WINSTAR Display Co.,Ltd.

Product Change Notification

■ Description: In order to improve production efficiency and yield, and more in line with the in-house process, the following metal frame and PCB optimization changes will be made.

Effected Parts	WH4004A Series
----------------	----------------

■ Module Drawing Comparison

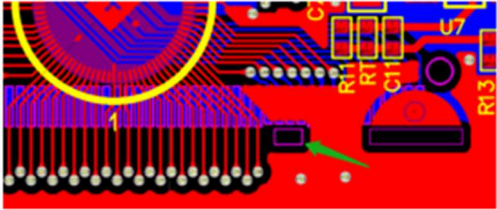
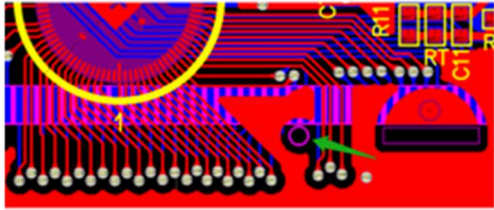
The metal frame increases the positioning column and the side seal opening

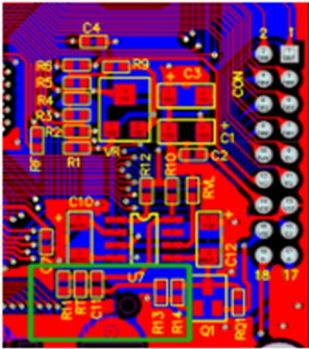
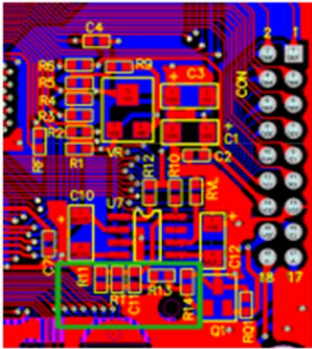
The positioning holes of the metal frame on the PCB are changed from square to round

Changes in the position of some components on the PCB
